## Draft Regulations

Building Act  
(chapter B-1.1)

#### Construction Code — Amendment

### Regulation to amend the Construction Code

**Figure A-1.1.2.1.  
Decision flow chart for Code compliance”;**

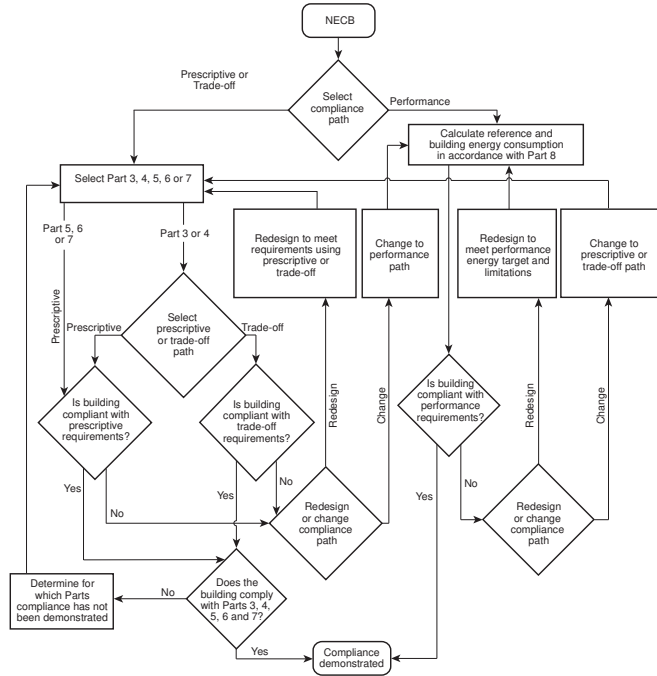
Replace Figure A-1.1.2.1. by the following:

**Figure A-3.1.1.6.(3)**

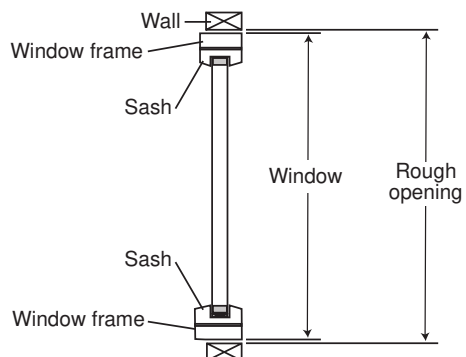
Figure A-3.1.1.6.(3) illustrates the requirements of Sentence 3.1.1.6.(3).

**Figure A-3.1.1.6.(5)**

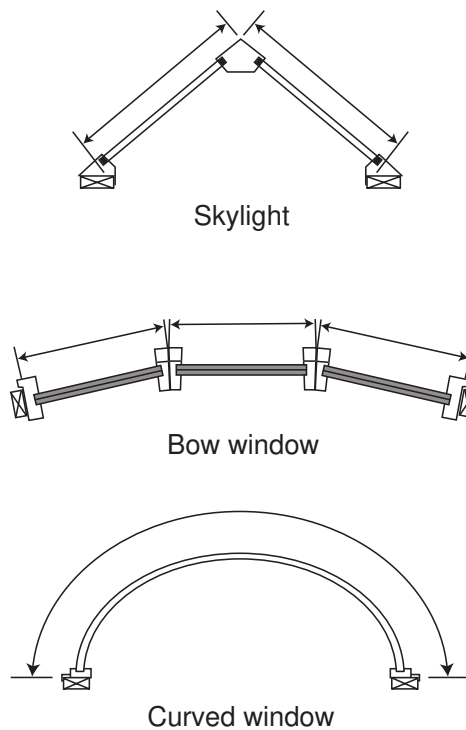
**A-3.1.1.6.(5) Areas of Other Fenestration.** Figure A-3.1.1.6.(5) illustrates how to measure the area of glass panes as described in Sentence 3.1.1.6.(5).

**Figure A-3.2.1.2.(3)-A**

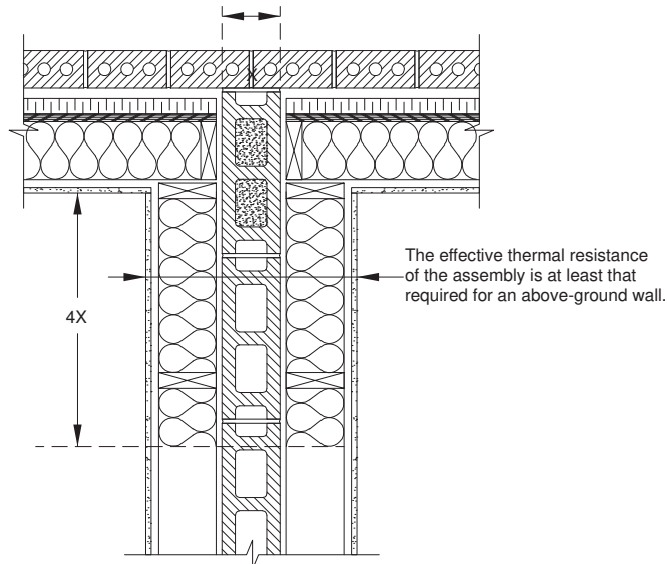
Figures A-3.2.1.2.(3)-A, A-3.2.1.2.(3)-B, A-3.2.1.2.(3)-C and A-3.2.1.2.(3)-D illustrate ways to comply with the requirements of Sentence 3.2.1.2.(3).

**Figure A-3.2.1.2.(7)**

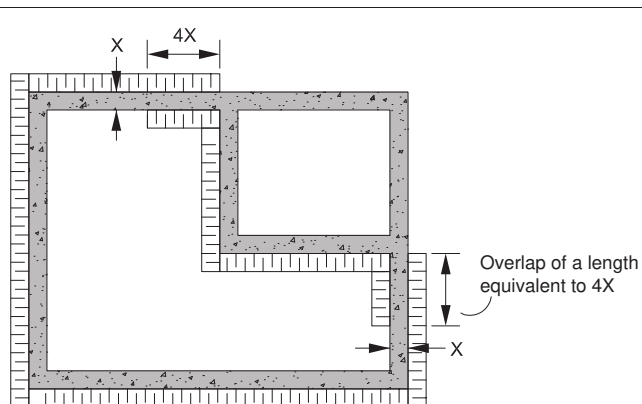
<p>Add the following Notes:</p> <p><b>“A-3.2.1.2.(7) Insulation Overlap.</b> Where the break in insulation is due to the perpendicular interposition of a member of the envelope relative to another, Sentence 3.2.1.2.(7) requires that the overlap be carried out to extend the path of least thermal resistance from the inside out or toward an unheated adjacent space, as illustrated in Figure A-3.2.1.2.(7).</p>

**Figure A-3.2.2.2.(5)**  
**Reduction of the sloped insulation on a flat roof in accordance with Sentence 3.2.2.2.(5)**

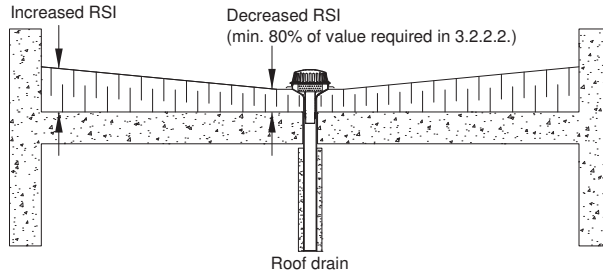
**A-3.2.2.2.(5) Effective Thermal Resistance of a Flat Roof.** Sentence 3.2.2.2.(5) allows the reduction of the effective thermal resistance around the drain of a roof provided that the dimension of the roof and the slope are sufficient to offset heat losses incurred in the portion that does not comply with the requirements of Article 3.2.2.2. Figure A-3.2.2.2.(5) illustrates the application.

**Figure A-3.2.2.2.(6)**  
**Insulation reduction allowed for sloped roofs in accordance with Sentence 3.2.2.2.(6)".**

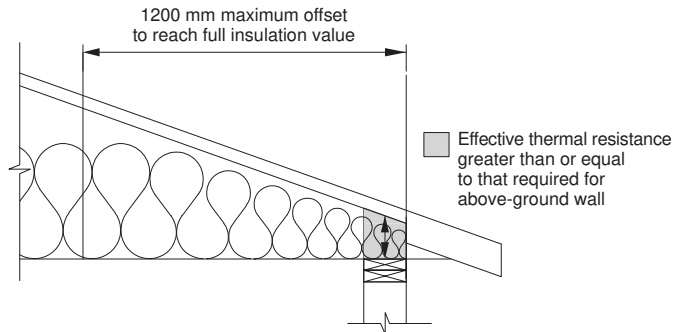
**A-3.2.2.2.(6) Effective Thermal Resistance Near the Eaves.** The values of the effective thermal resistance required for roofs with attic spaces are greater than those required for walls. The reduction allowed in Sentence 3.2.2.2.(6) assumes that the thickness of the insulation will be increased on the basis of the increase of the slope of the roof with an attic space until the space is sufficient to contain the full thickness of the insulation. Figure A-3.2.2.2.(6) illustrates the reduction allowed in that Article.

**Figure A-3.2.3.1.(3)**  
**Insulation of walls in contact with the ground”.**

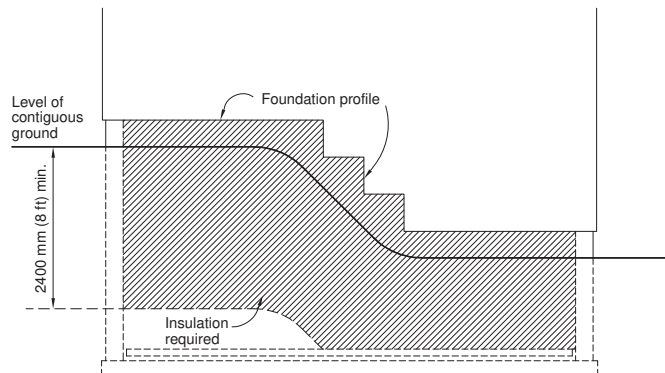
**A-3.2.3.1.(3) Wall in Contact with the Ground.** The term “ground level” as used in Sentence 3.2.3.1.(3) has a different meaning than “grade”, which is defined in the NBC. The wording in Sentence 3.2.3.1.(3) requires that the bottom of the insulation follow the contours of the exterior ground level at the required depth, as shown in Figure A-3.2.3.1.(3).

**Figure A-3.2.3.1.(4)**

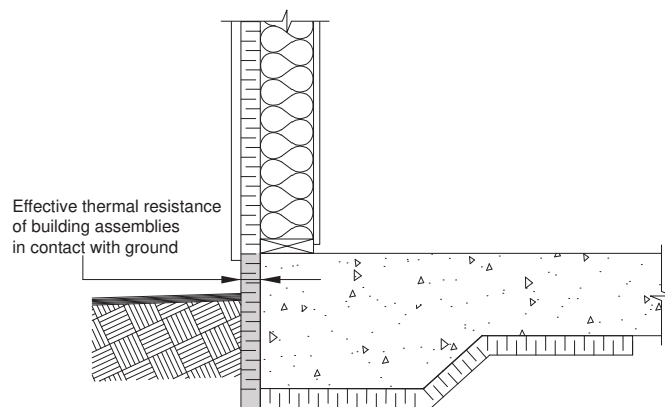
**“A-3.2.3.1.(4) Slab-on-Ground.** Sentence 3.2.3.1.(4) requires that the vertical section of a slab-on-ground be insulated over its entire height just like a wall in contact with the ground in accordance with the requirements of Sentence 3.2.3.1.(1), as shown in Figure A-3.2.3.1.(4).

**Figure A-5.2.2.9.-A**

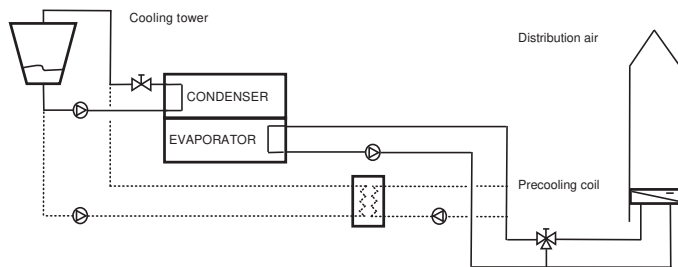
A-5.2.2.8.(6)	<p>Strike out the Note.</p>
	<p>Add the following Note:</p> <p><b>“A-5.2.2.9. Water Economizer System.</b> The water economizer system reduces the mechanical cooling load by cooling the heat transfer fluid of the cooling system with outdoor air. The energy savings are made by reducing the compressor use time. There are two typical compliant configurations for the water economizer system,</p> <ul style="list-style-type: none"> <li>• evaporation cooling, also called “water precooling,” such as that shown in Figure A-5.2.2.9.-A, and</li> <li>• sensible heat transfer cooling, also called “air precooling,” such as that shown in Figure A-5.2.2.9.-B.</li> </ul> <p>The dotted lines represent the portion of the economizer system.</p>

**Figure A-5.2.3.1.**

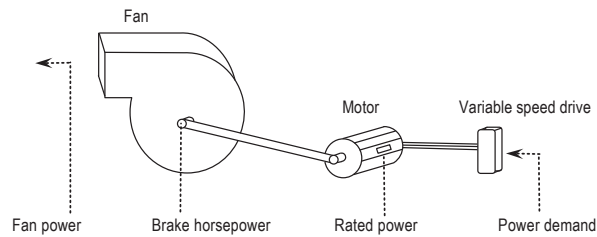
Figure A-5.2.3.1. shows the various locations where the capacity of a fan can be measured.

**Figure A-5.2.3.1.(1), (2) and (3)**

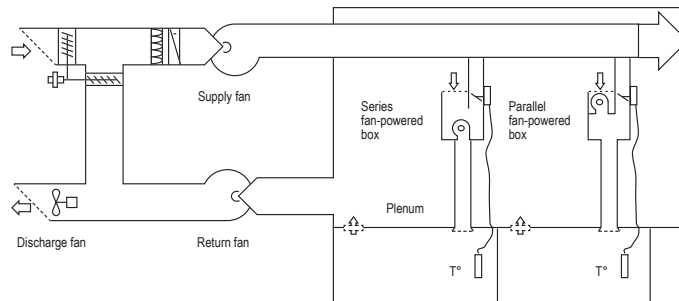
- belong to the same HVAC system. Figure A-5.2.3.1.(1), (2) and (3) shows an example of an HVAC system with multiple fans. For example, if two HVAC systems have their own supply fans, their own heating and cooling coils and serve the same zone, they are considered to be two separate HVAC systems even if they serve the same zone. Two separate calculations must then be made to establish the total of the powers,
- operate when the two design conditions, heating and cooling, are met. The power limit of 4 kW applies to fans whose total rated capacity is the highest between the heating conditions and the cooling conditions, and
- carry heated or cooled air. The calculation must take into account all the supply fans, return fans, relief fans, and fans for series fan-powered boxes.

**Figure A-6.2.3.1.(1) and (5) and 6.2.3.2.(1)**

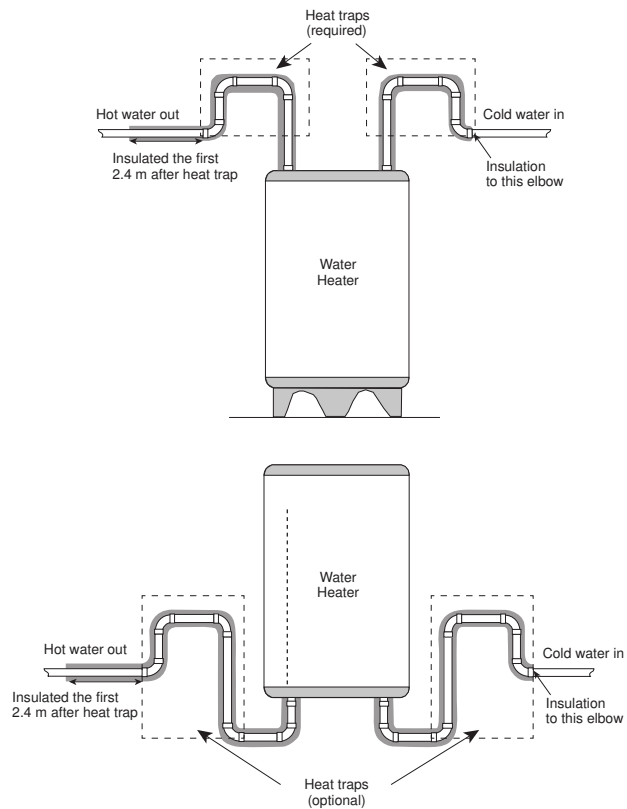
**"A-6.2.3.1.(1) and (5) and 6.2.3.2.(1) Heat Traps.** ASHRAE/IES 90.1, "User's Manual," defines a heat trap as follows:

Figure A-6.2.3.1.(1) and (5) and 6.2.3.2.(1) illustrates two examples of site-built heat traps."
